27 February 2023

Our Ref  
P1806743JC06V01

**RE: SUPPLEMENTARY FLOOD ASSESSMENT IN RESPONSE TO SHOALHAVEN CITY COUNCIL AND BIODIVERSITY AND CONSERVATION DIVISION COMMENTS – PROPOSED EXPANSION OF SAND EXTRACTION AT PIG ISLAND, TERARA, NSW**

FL01	Map
Pig Island, Terara, NSW	Site
Expansion of Sand Extraction	Project
Flood Assessment	Sub-Project
Terara Shoalhaven Sand	Client
27/02/2023	Date

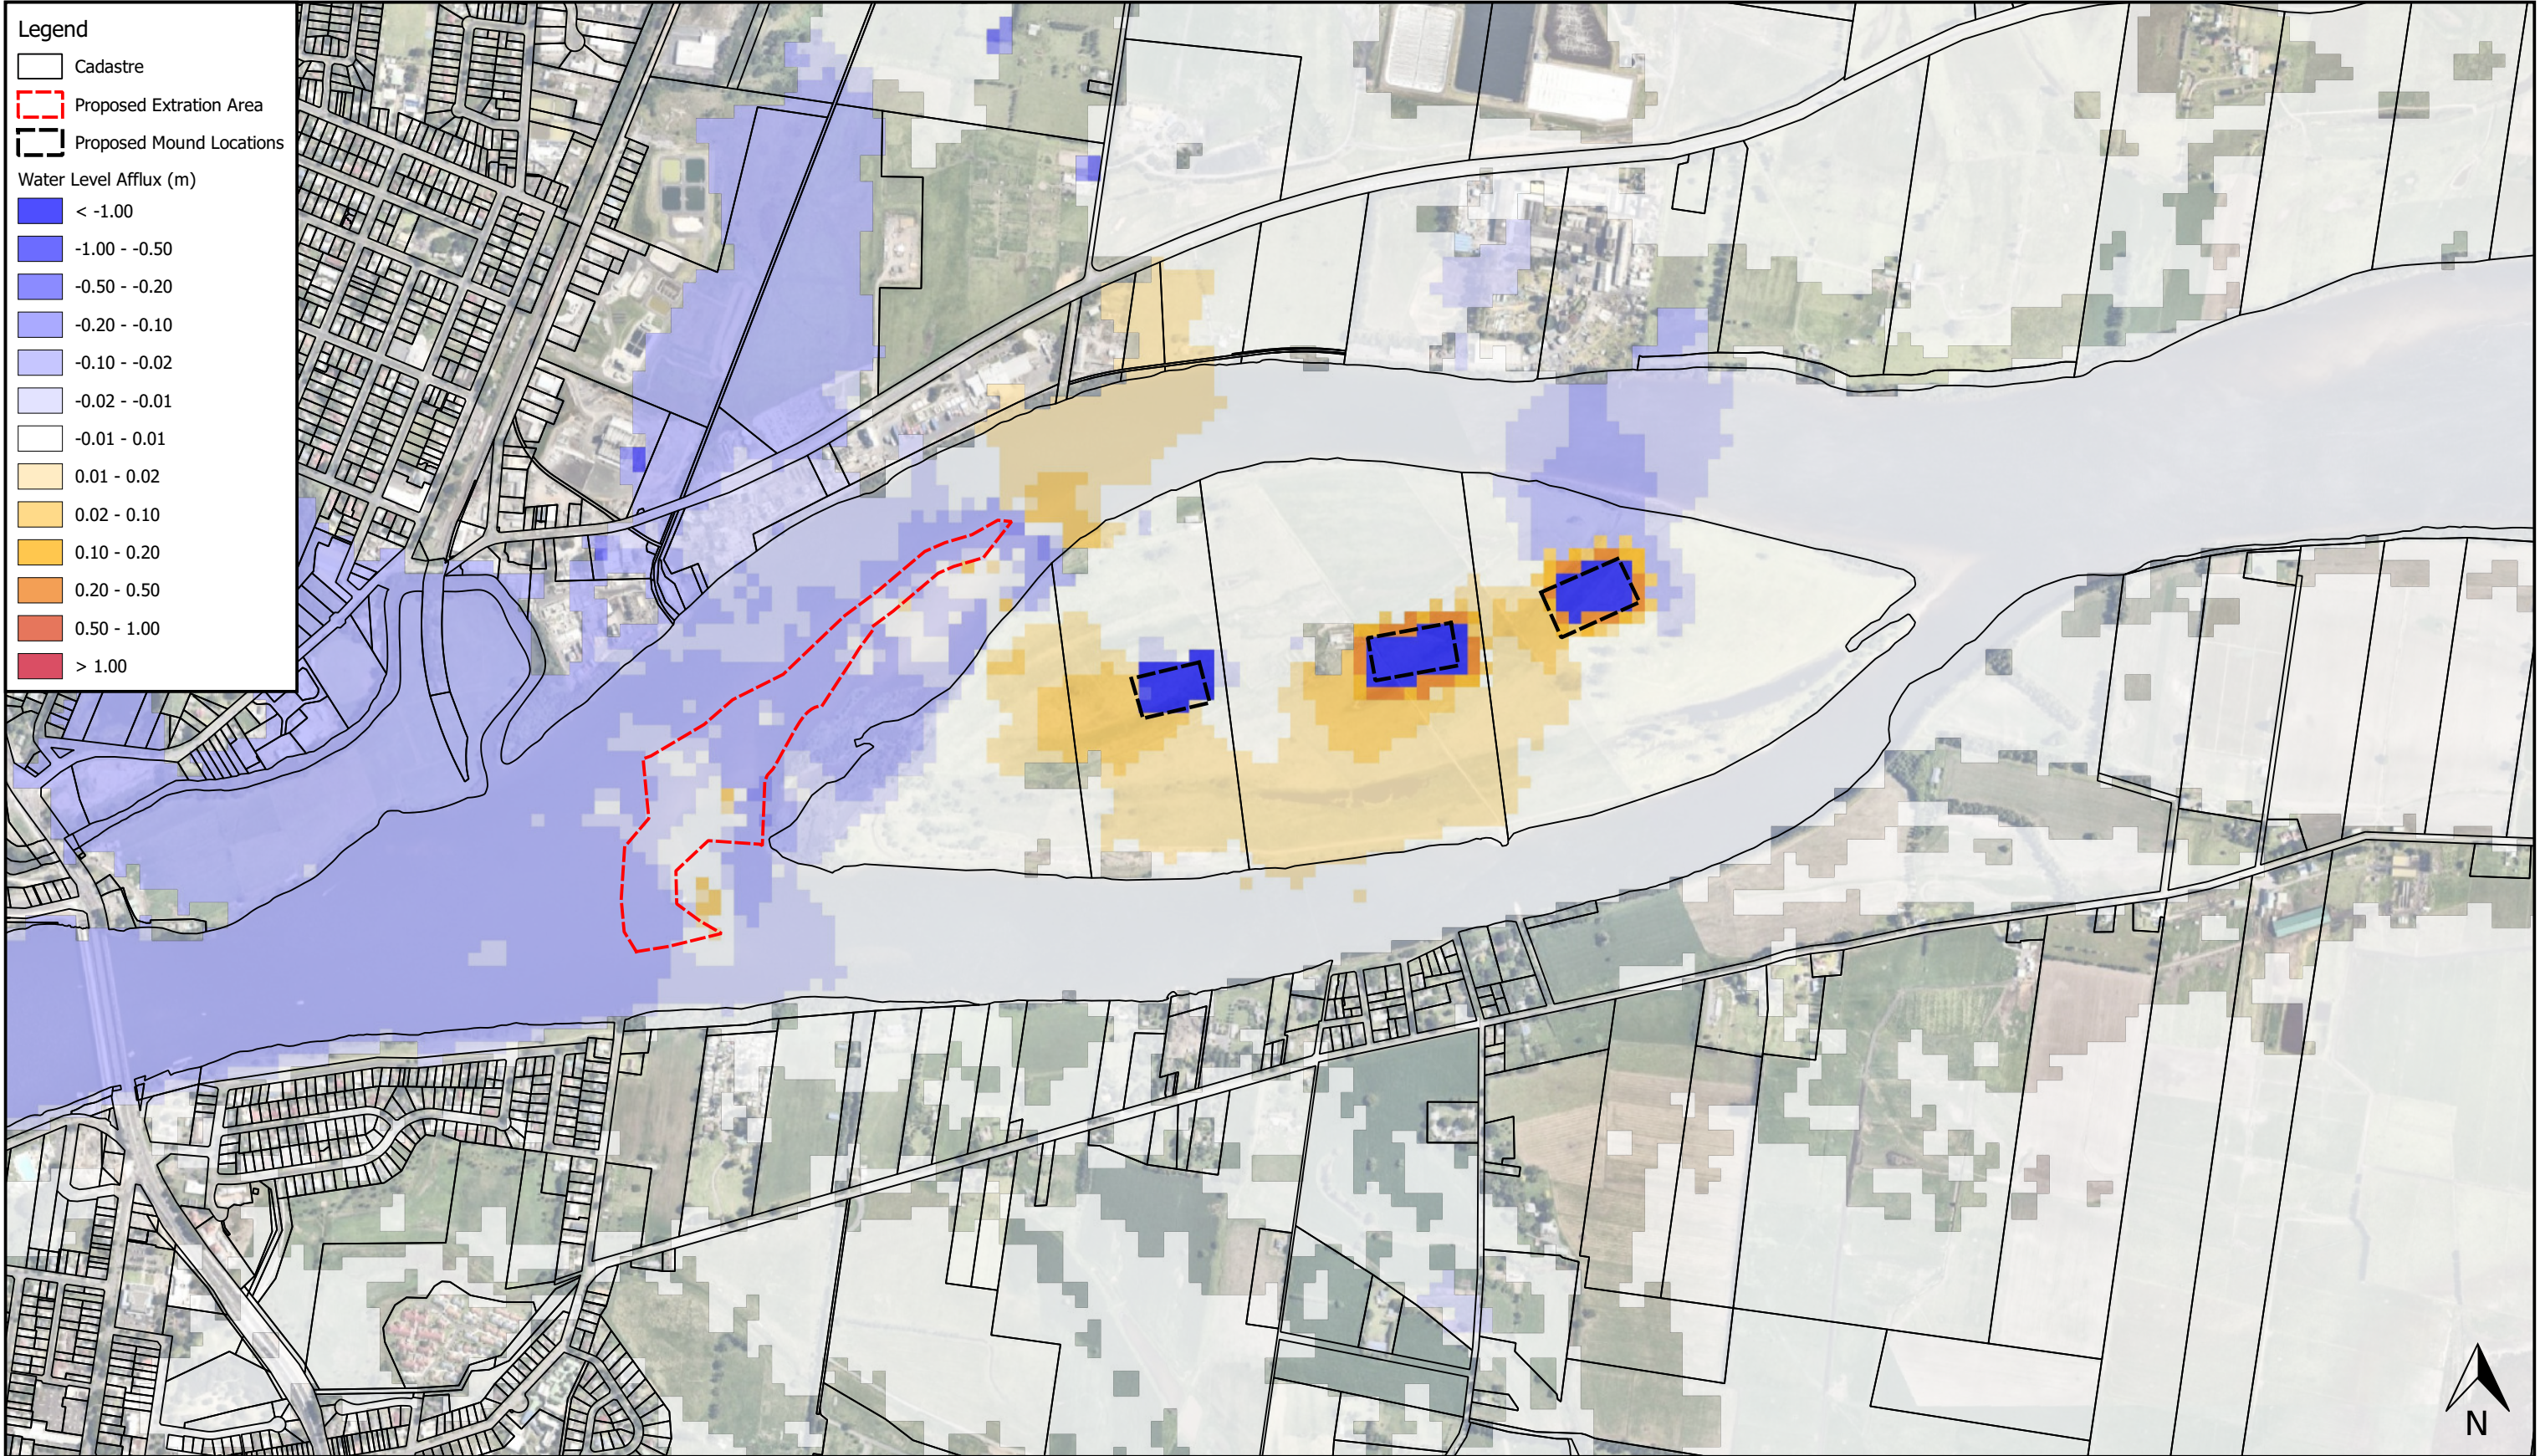
Comparison between Cardno (2022) and MA peak flood levels for the 1% annual exceedance probability (**AEP**) flood and probable maximum flood (**PMF**) events is given in Table 1. Comparison is made for the peak flood levels at the 6 locations shown in Attachment A Map FL01. The comparison shows flood levels as modelled by MA are generally consistent with Cardno modelling, and differences are  $\leq \pm 0.5$  m. MA modelled flood levels are slightly higher than those modelled by Cardno and are therefore considered conservative. Further, flood levels and extents throughout the MA model domain were compared to those modelled by Cardno and were found to have close agreement. We therefore consider the MA model closely matches the Council adopted flood characteristics, and is considered appropriate for the purposes of detailed site modelling.

FL02	Map
Pig Island, Terara, NSW	Site
Expansion of Sand Extraction	Project
Flood Assessment	Sub-Project
Terara Shoalhaven Sand	Client
27/02/2023	Date

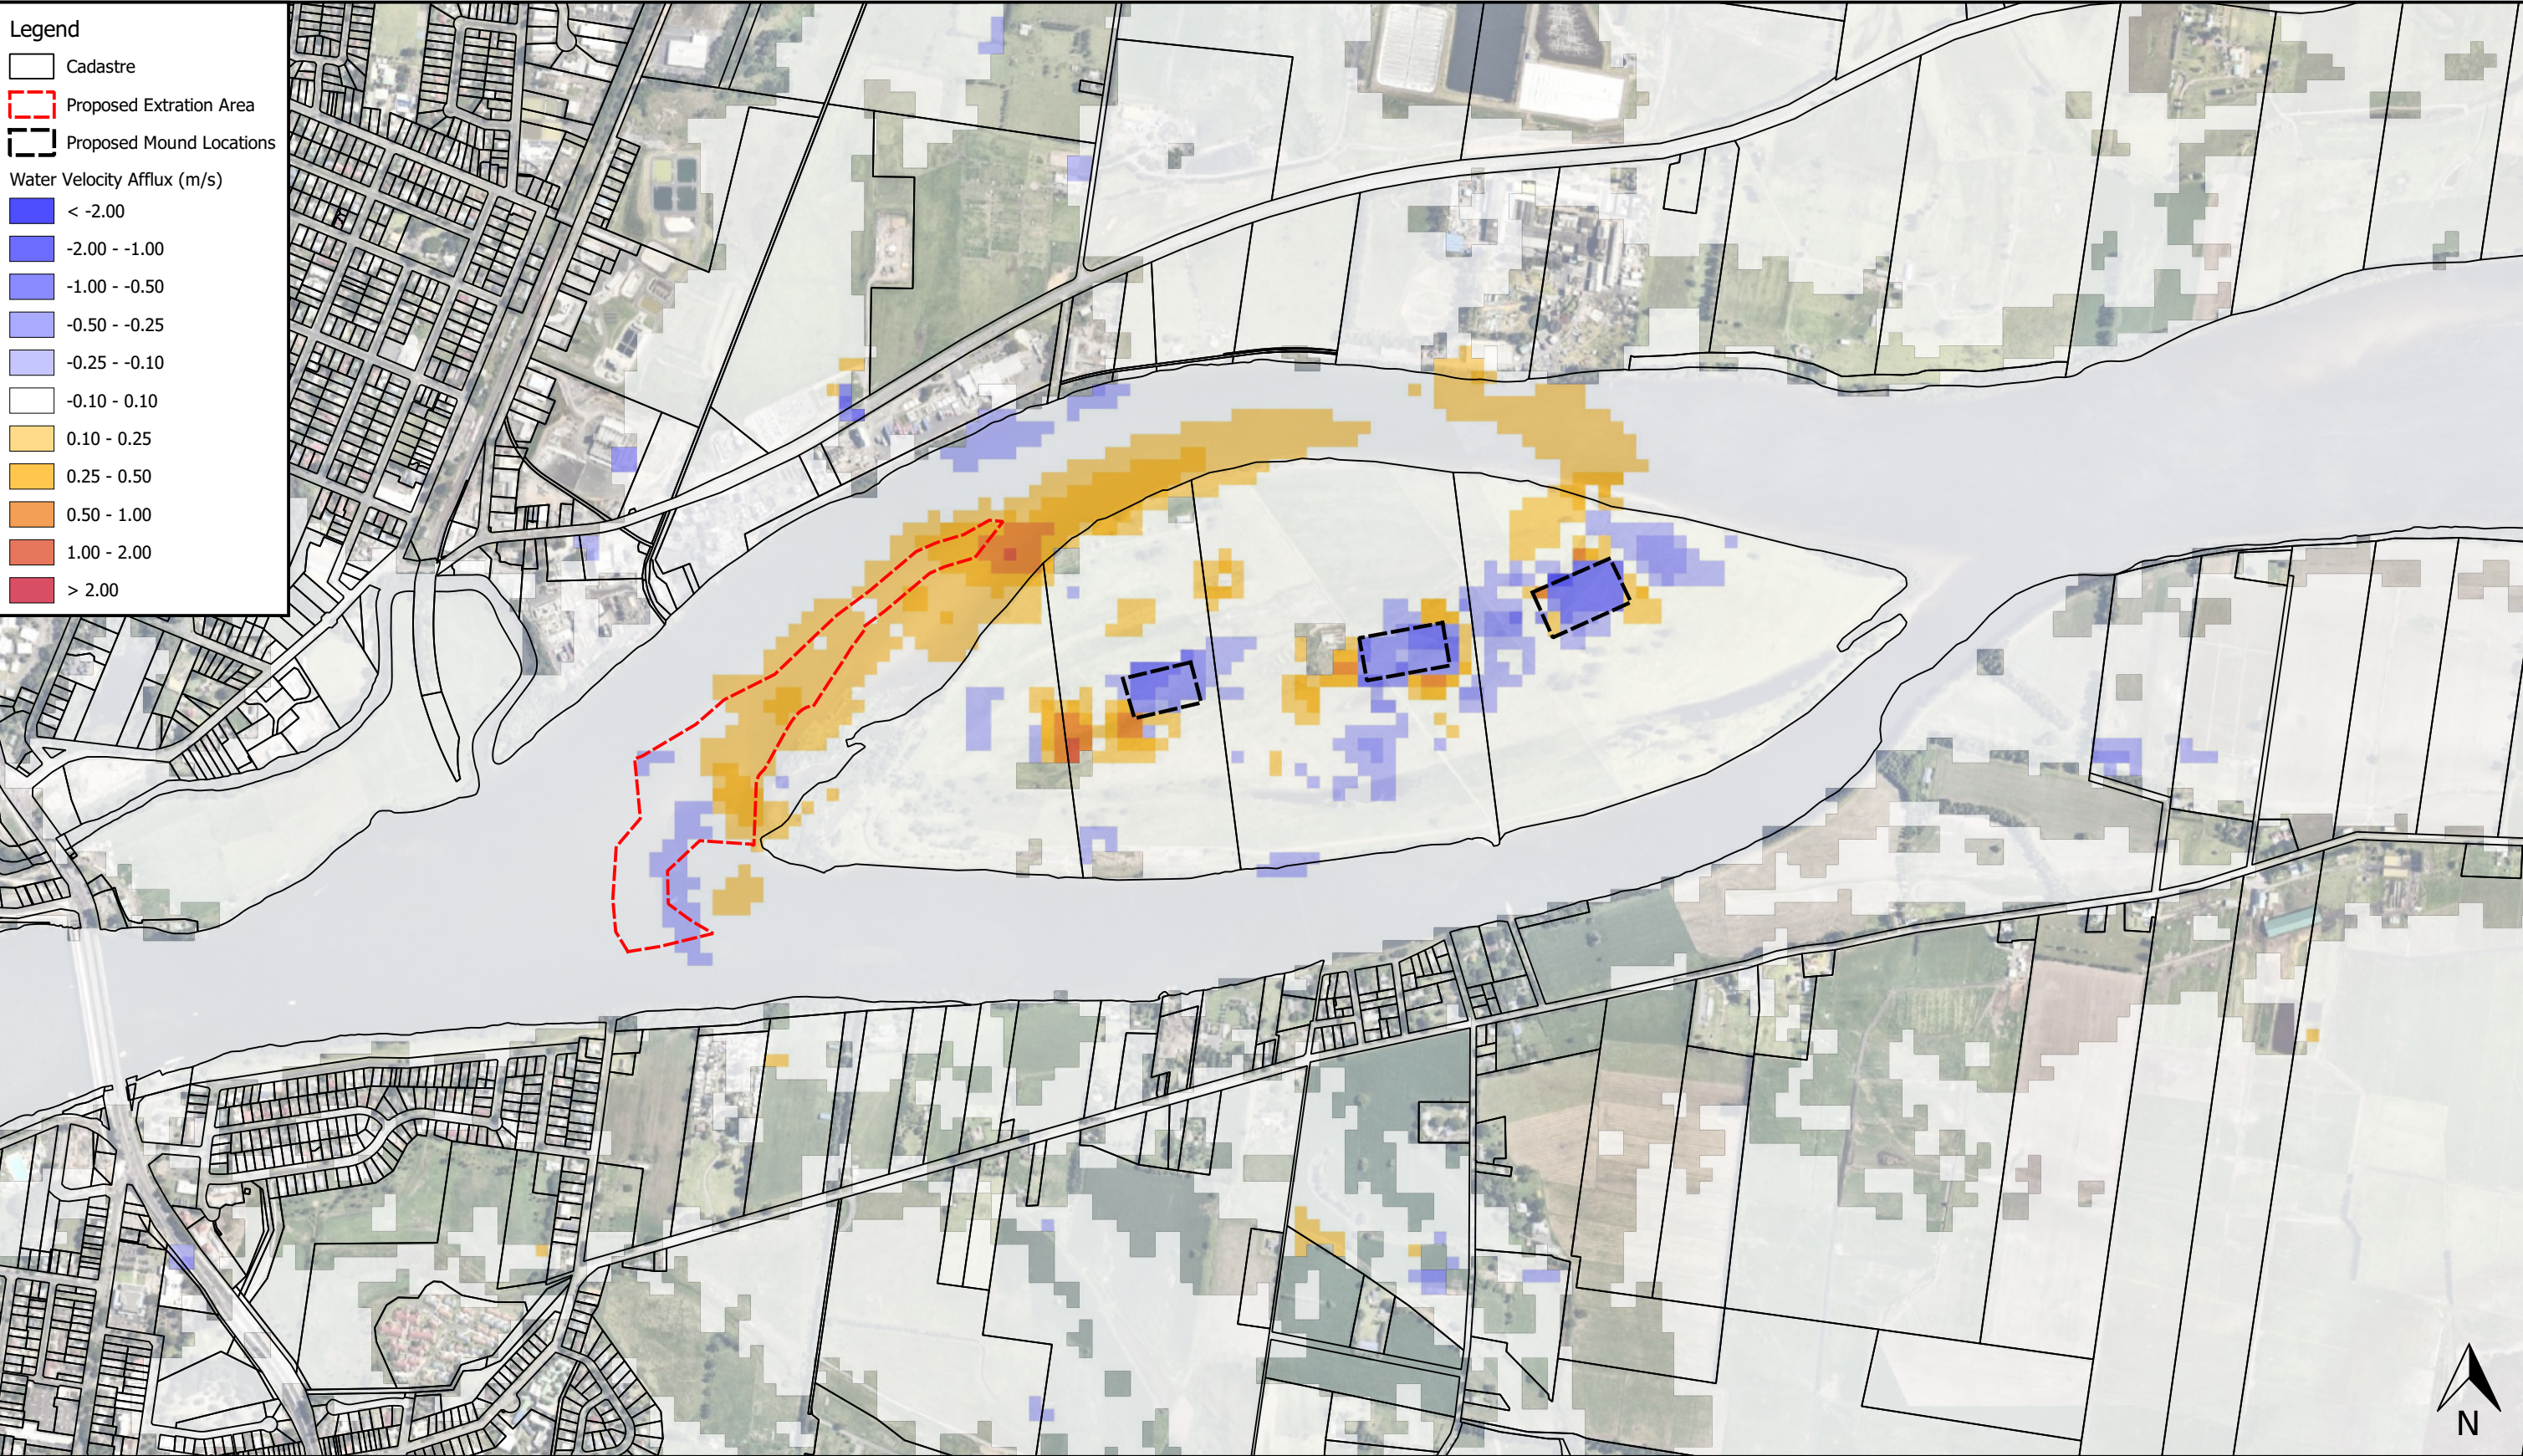
2. Despite the strict 10 mm threshold requested by Council, modelling has shown the proposed development has negligible offsite water level impacts in all modelled flood events up to and including the PMF.

3. There are minimal flood level increases above 10 mm on private land for all events up to and including the PMF event. These flood level increases are negligible considering the flood depths in existing conditions of up to 2.1 m in the 10% AEP event and 9.2 m in the PMF event.
